Product Change Notification

PCN-PCC-6421-2020

Business Unit	Product Line Code	Type of Change	Action	Date of Issue
PCC - PCB Connectors	AAB	Product Change Notification	Notify Distributors and Field	12/17/2020

Description for Product Change Notification

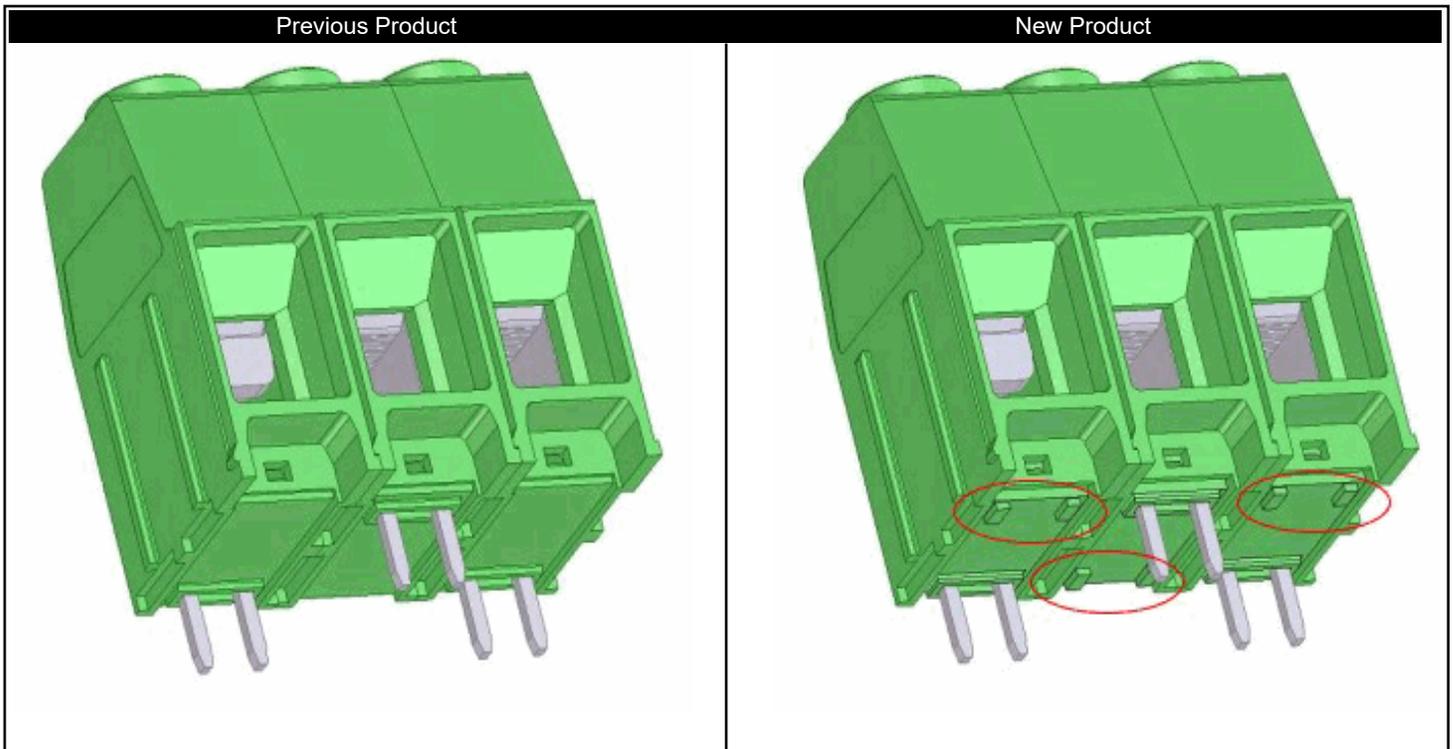
As part of our ongoing improvement process, the contour of the MKDS 10 HV terminal block base is being changed. Two ribs will be added. These additional ribs help prevent the housing from moving when forces are applied to the terminal sleeve, therefore simplifying operation. Shipments of the new versions are expected to begin on April 1, 2021 depending on local inventory. The version/revision level (V/C) will be changed as noted on the attached spreadsheet.
